**DEVIATION REQUEST  
AND DECISION FORM**

Project Name : Saddlehorn Ranch – Filing 2  
 Schedule No.(s) : 4300000602  
 Legal Description : SEE ATTACHED – Exhibit C

A deviation from the standards of or in Section **ECM section 4.3.6.3 Underground Utilities Standards** of the Engineering Criteria Manual (ECM) is requested for the culverts in Saddlehorn Filing 2.

<p>UNTIL SUCH TIME AS THESE DRAWINGS ARE APPROVED BY THE APPROPRIATE REVIEWING AGENCIES, OR ENGINEERING APPROVES THEIR USE, THESE DRAWINGS ARE DESIGNATED BY WRITTEN AUTHORIZATION.</p>	
<p>PREPARED FOR <b>ROI PROPERTY GROUP, LLC</b> 1280 S. 800 E, SUITE 200 OREM, UTAH (949) 609-9492 NATHAN STEELE</p>	
<p><b>J.R. ENGINEERING</b> A Westman Company Central 303-740-9888 • Colorado Springs 719-583-2583 Fort Collins 970-491-9888 • www.jrengineering.com</p>	
No.	REVISION
H-SCALE	1"=200'
V-SCALE	N/A
DATE	5/1/24
DESIGNED BY	AAM
DRAWN BY	AAM
CHECKED BY	
<p>SADDLEHORN RANCH - FILING 2 CULVERT VARIANCE EXHIBIT</p>	
SHEET	1 OF 1
JOB NO.	25142.04

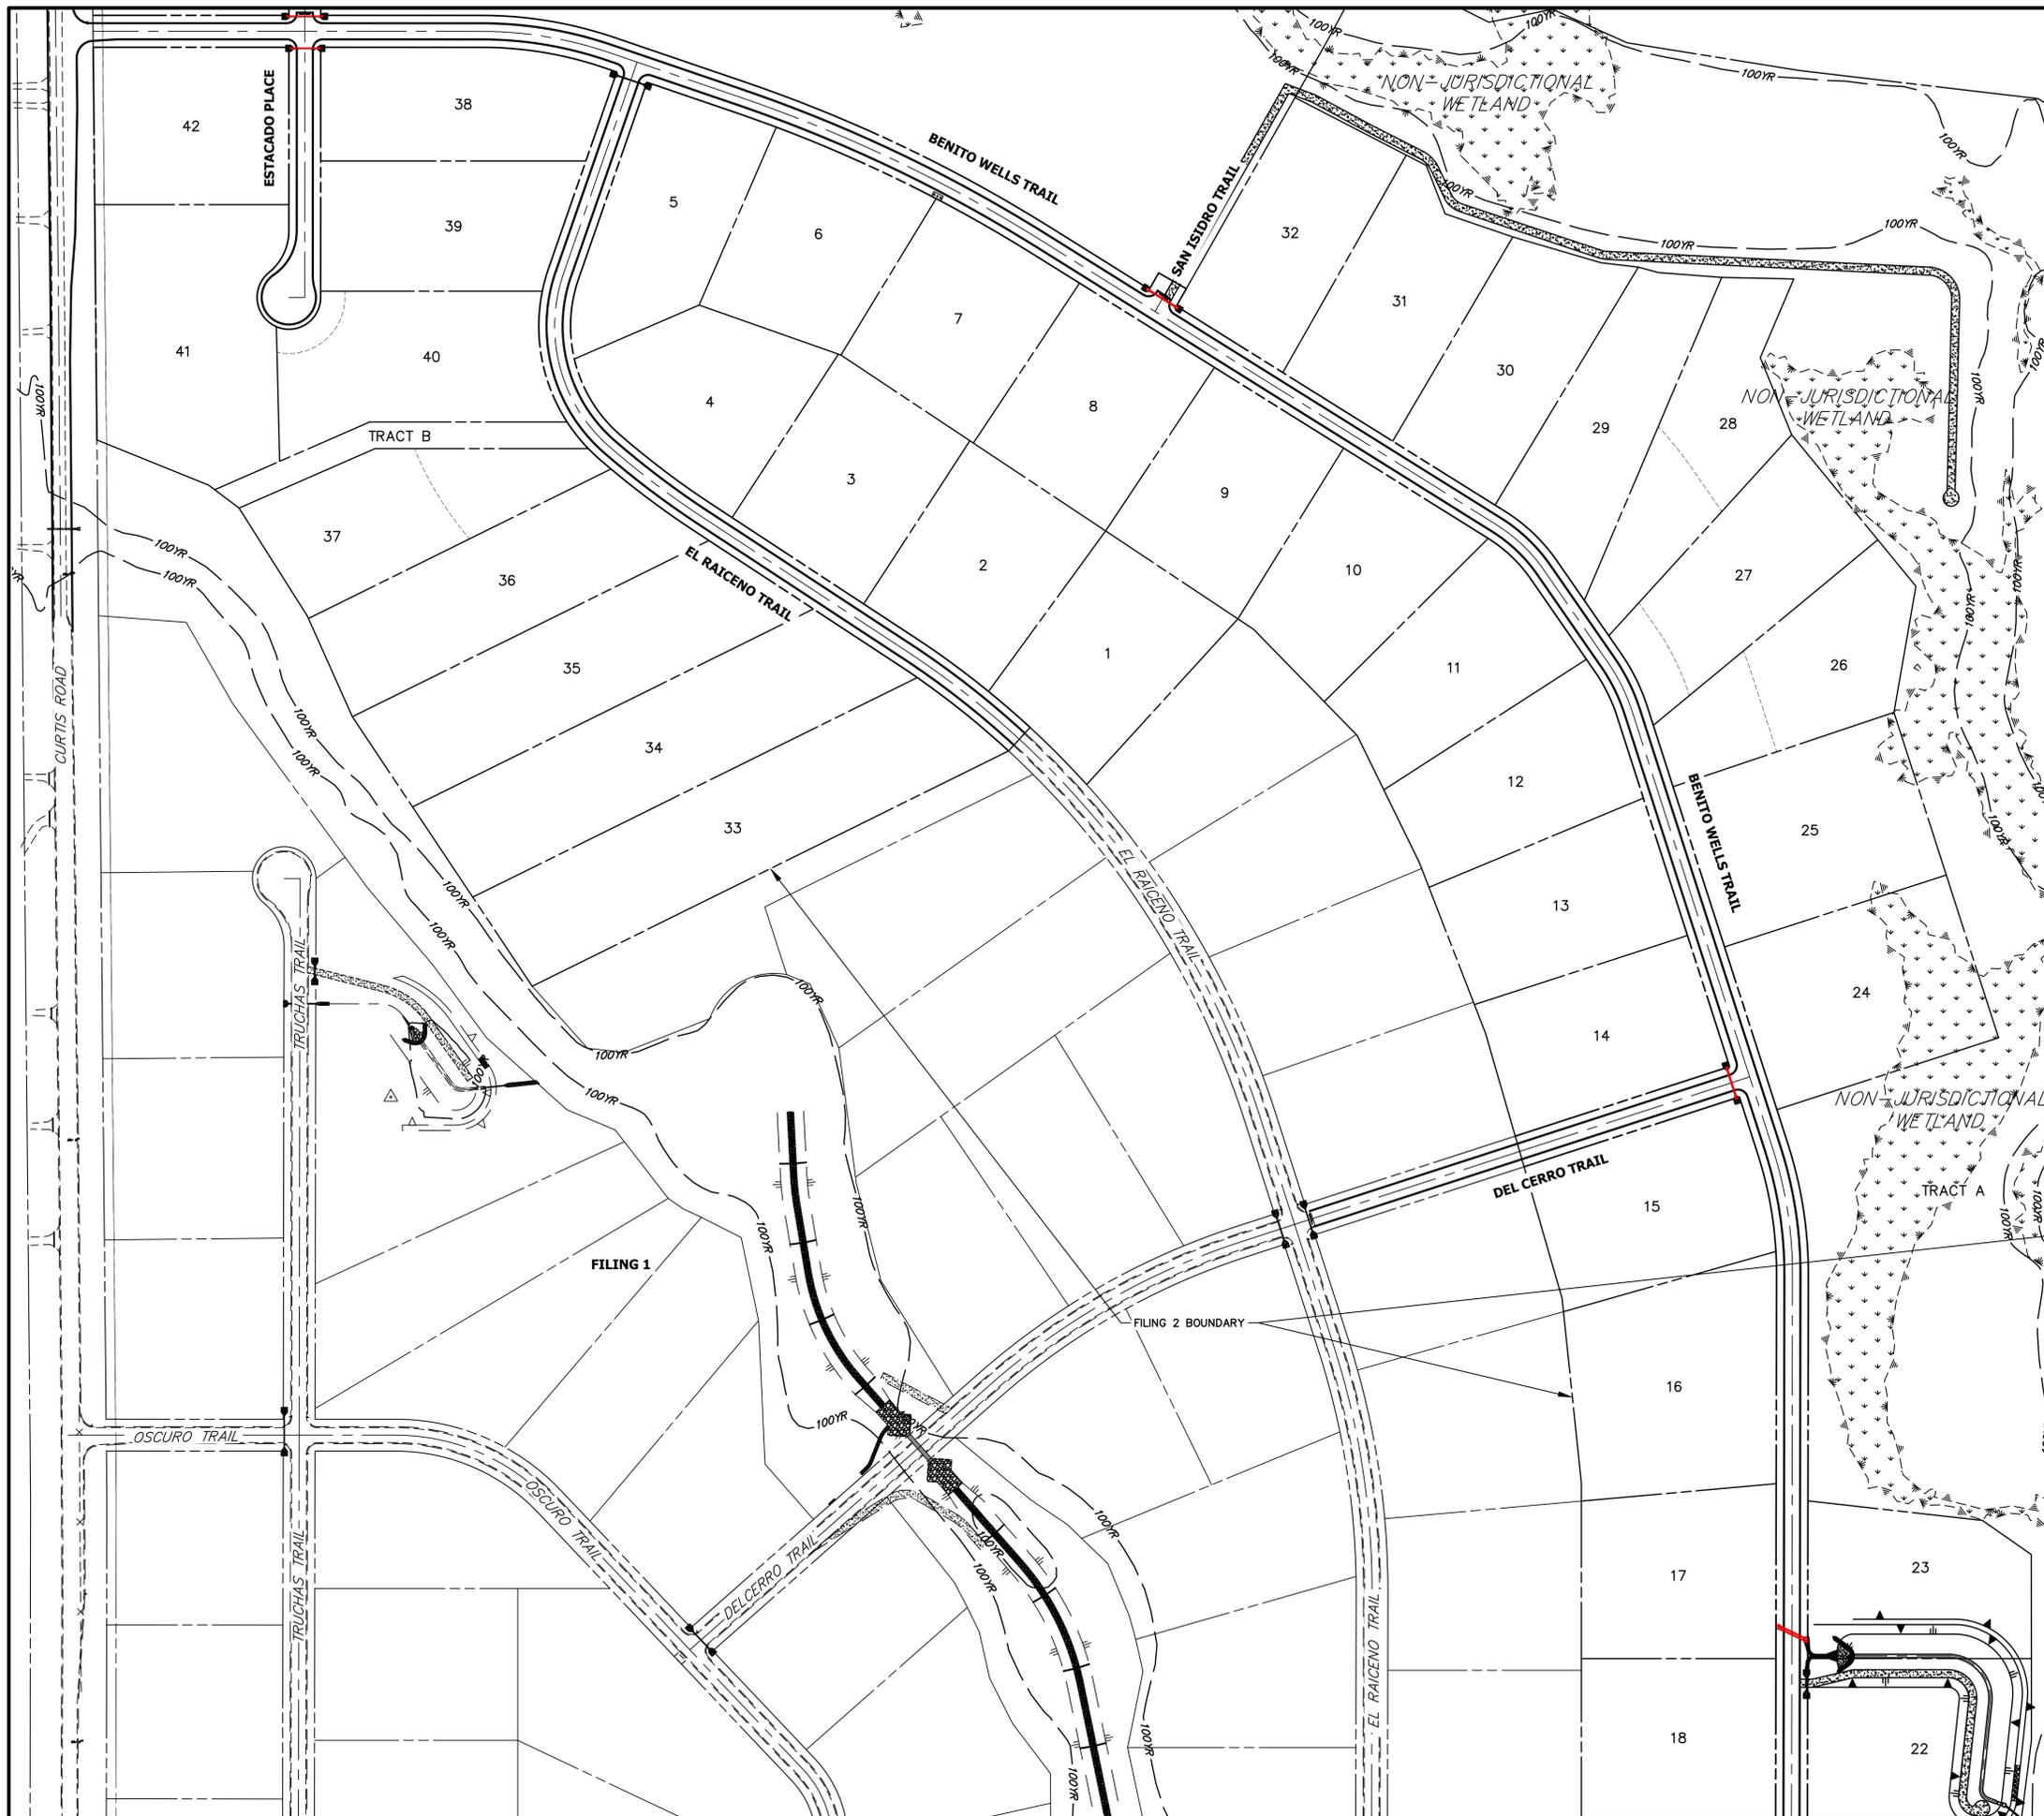
Criteria for cover of storm sewer lines per the ECM, shall be no less than 2 feet. The following request will be to deviate from this minimum, and instead request to utilize CDOT Standard M-603-2.

In order to keep Pond F out of the groundwater table, the pond was constructed close to existing grade. Because this pond is the sole outfall for Filing 2, the roads and adjacent swales were constructed at 1% slopes in order to convey runoff from Curtis road all the way to Pond F. To maintain this drainage pattern, the culverts were proposed to have 1'-1.8' of cover. This allowed the swales to maintain a 1% slope, while still allowing the culverts to function as intended without specialty elliptical culverts, which will be more difficult to maintain over time.

For storm sewer design, a minimum cover of 2 feet is required, per 4.3.6.3 of the ECM. This deviation proposes a reduction of this cover, and instead utilize CDOT's M-603-2 standard for culvert design. This CDOT standard allows a minimum of 1' of cover from the top of the pipe, and includes the pavement thickness. The AASHTO LRFD tables were also used to check the Class III concrete pipe strength at each fill height. This will ensure the culverts can withstand AASHTO traffic loading for the rural roads. A total of 5 culvert crossings will be impacted by this deviation. See Exhibit C for culvert locations.
